State of Ohio Environmental Protection Agency

May 13, 2009

Re: Jackson County
Village of Oak Hill WWTP
Ohio EPA Permit No. 0PB00055*GD
NPDES Permit No. OH0026859
Compliance Evaluation Inspection
Correspondence (PWW)

NPDES
Compliance Inspection Report

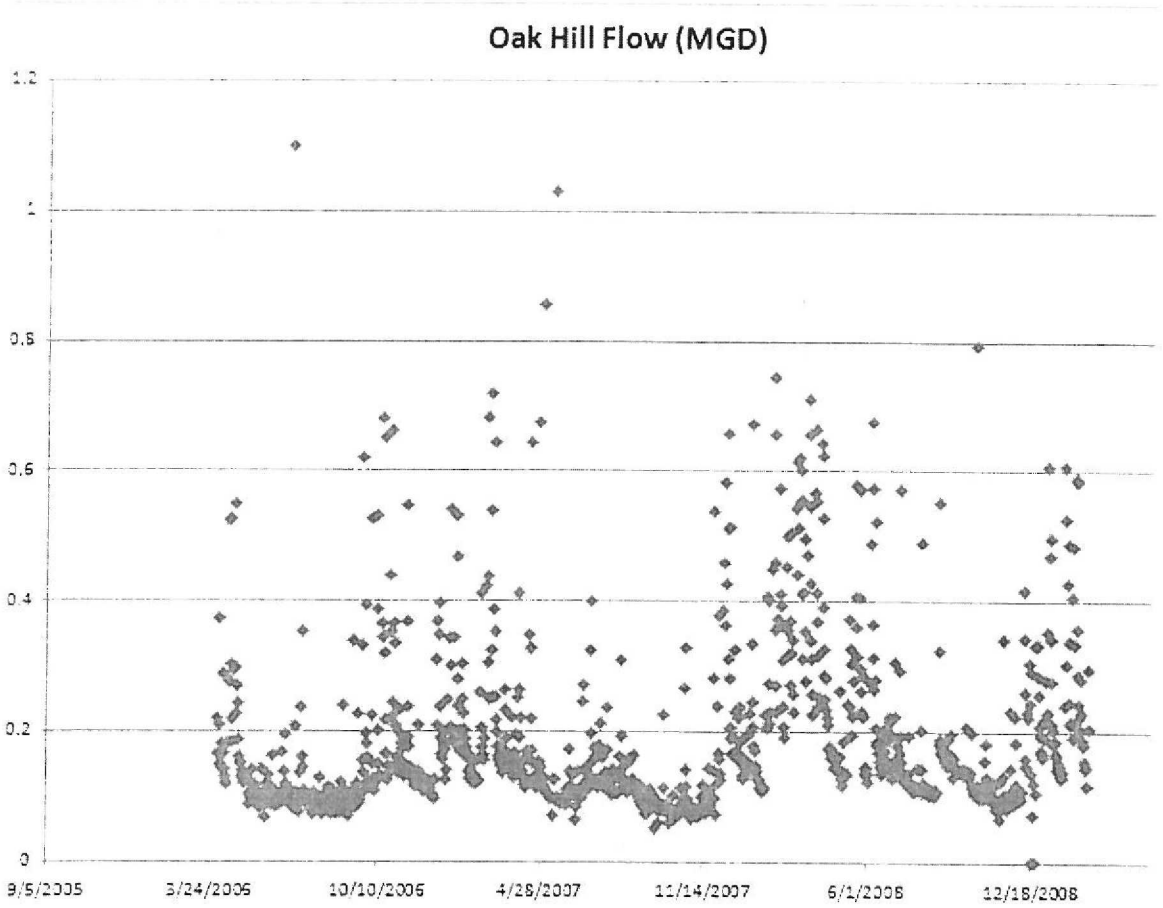
The permit requires on page 10 Part I, C. that an Inflow and Infiltration Control Plan to be submitted to the Ohio EPA, Southeast District by October 1, 2007. The Village hired Jones & Henry Engineers. A copy of the plan had been sent to the Village; the agency is still waiting on a copy. Please identify in your response to this letter a timeframe for completing the submission of the Inflow and Infiltration Control Plan. As seen in the charted data below, I&I is a relevant issue with a design flow of 0.3MGD.
